# STAFF RECOMMENDATION

NCPC File No. 6648

**UNITED STATES DEPARTMENT OF COMMERCE**  
**BUILDING MODERNIZATION AND PERIMETER SECURITY**  
Herbert C. Hoover Building  
14th Street, NW and Constitution Avenue, NW  
Washington, DC

March 30, 2006

**National Aquarium – Enlarged Entrance Plan**

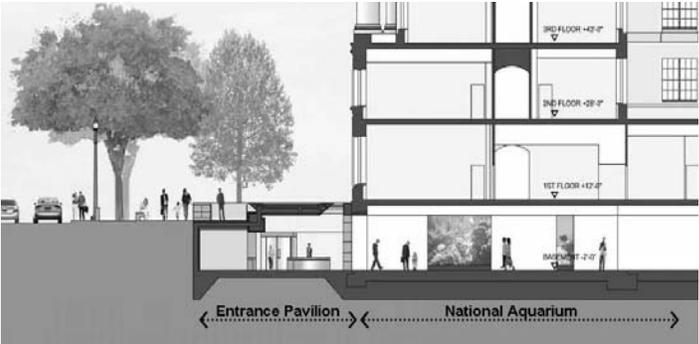
Staff supports the relocation of National Aquarium adjacent to Constitution Avenue. The orientation, adjacent to the Mall and the future National Museum of African American Culture and History, will increase public awareness and attendance and will activate pedestrian activity along Constitution Avenue. Staff recommends maximizing pedestrian circulation space in front of the entrance areaway by incorporating perimeter security into the entrance design and eliminating streetscape security elements and clutter. Staff recommends further design study of the entrance element in consultation with NCPC, CFA and DC SHPO staffs in order to minimize the impact to the historic building yard and building fabric, setting and street-level view sheds.

**Proposed Perimeter Security Site Plan**

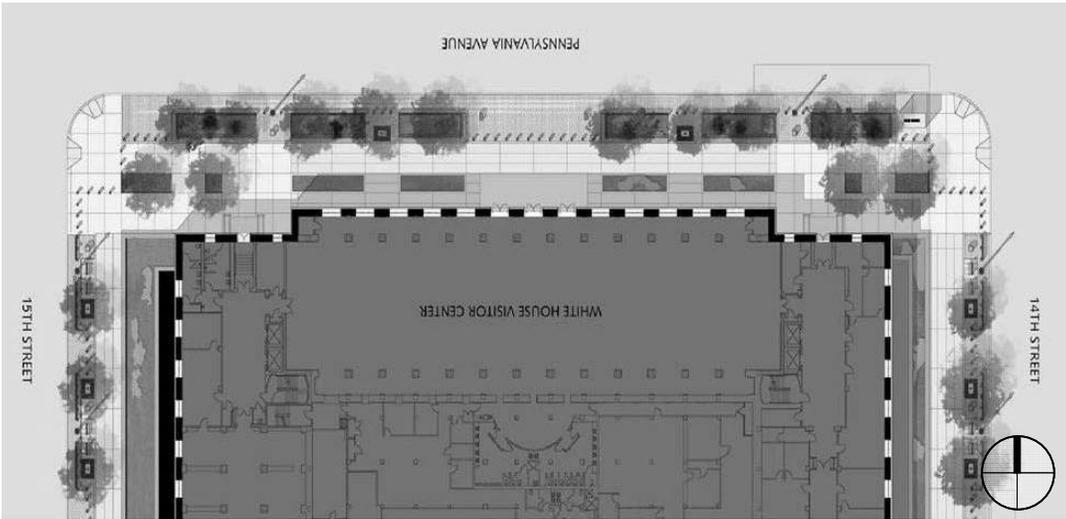
Staff finds the proposal for perimeter security enhancements to be premature and recommends that further action on this element be deferred until it can be coordinated with efforts to develop a comprehensive design solution for perimeter security and streetscape improvements in the entire Federal Triangle including Constitution and Pennsylvania Avenues. Since December 2001 the Commission has understood that GSA would pursue such a comprehensive solution. Since 2004 the Commission has included as recommended and strongly endorsed two related projects in Federal Capital Improvements Program.

Staff finds that the proposed perimeter security concept is not entirely consistent with the design framework in the *National Capital Urban Design and Security Plan*, but does not recommend that the commission make specific recommendations for further design development without a comprehensive design solution for the Federal Triangle. While we continue to recommend that agencies use the *National Capital Urban Design and Security Plan* as a guide and resource, staff notes that perimeter security technologies and requirements have advanced since it was published in 2002.

**Pennsylvania Avenue Perimeter Security – Enlarged Plan**

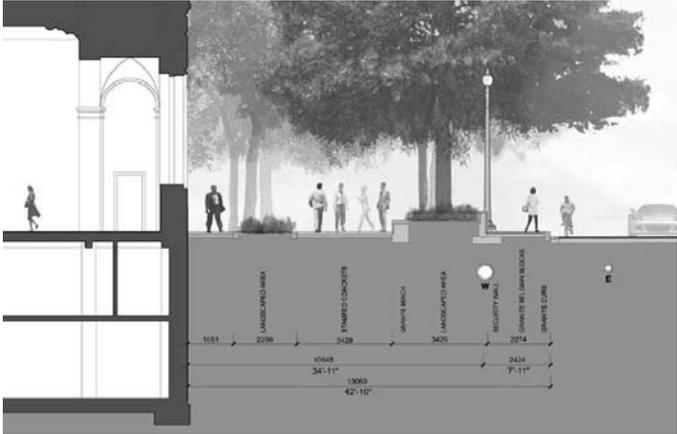
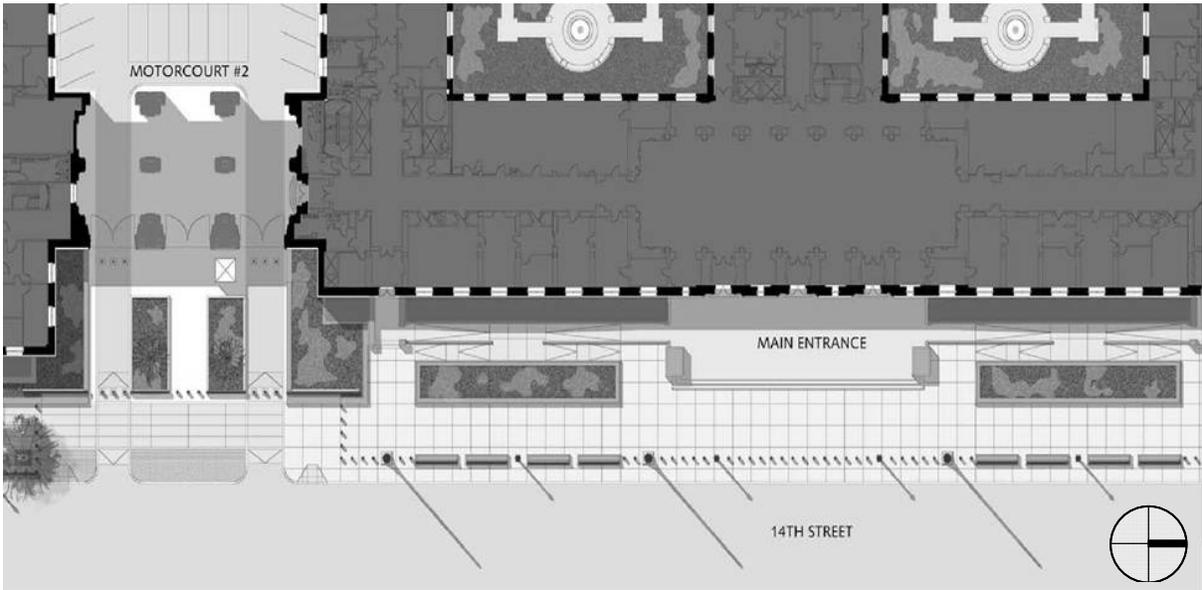
The design framework for Pennsylvania Avenue between 3<sup>rd</sup> and 15<sup>th</sup> Streets, as contained in the *National Capital Urban Design and Security Plan*, reinforces the existing streetscape of the avenue by incorporating new, custom-designed hardened street furniture. The plan notes, however, that the ultimate design direction for the avenue will be determined by the National Park Service. The proposed perimeter security concept and elements for Pennsylvania Avenue are not consistent with recommendation to incorporate new, custom-designed hardened street furniture and do not reflect coordination with the National Park Service for the remainder of Pennsylvania Avenue.

**14<sup>th</sup> Street Perimeter Security – Partial Enlarged Plan Main Entrance**

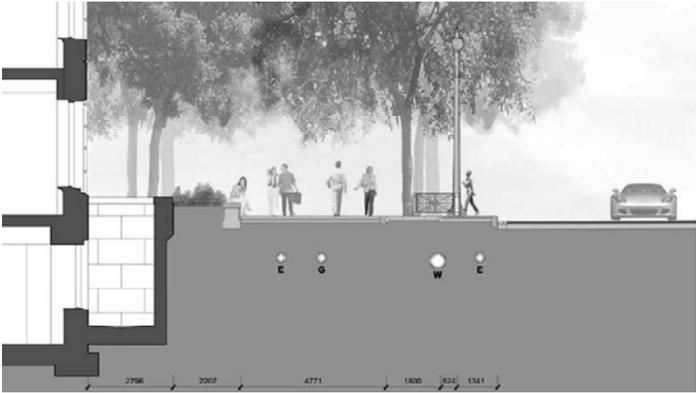
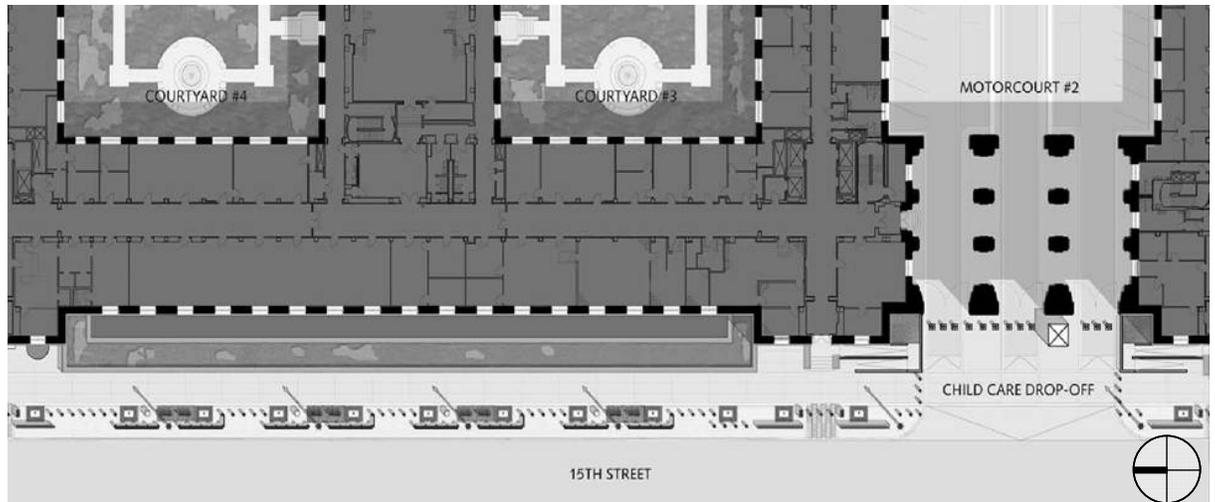
Staff finds that neither the proposed landscape plan nor the security elements proposed along 14<sup>th</sup> and 15<sup>th</sup> Streets (north-south streets) are consistent with the design framework recommended in the *National Capital Urban Design and Security Plan*. To minimize the impact of security in public space and ensure a well designed streetscape, the plan recommends additional trees and a cohesive palette of street furniture comprising of a variety of hardened security elements. The concept design also does not include uniform streetscape design information for both sides of 14<sup>th</sup> Street.
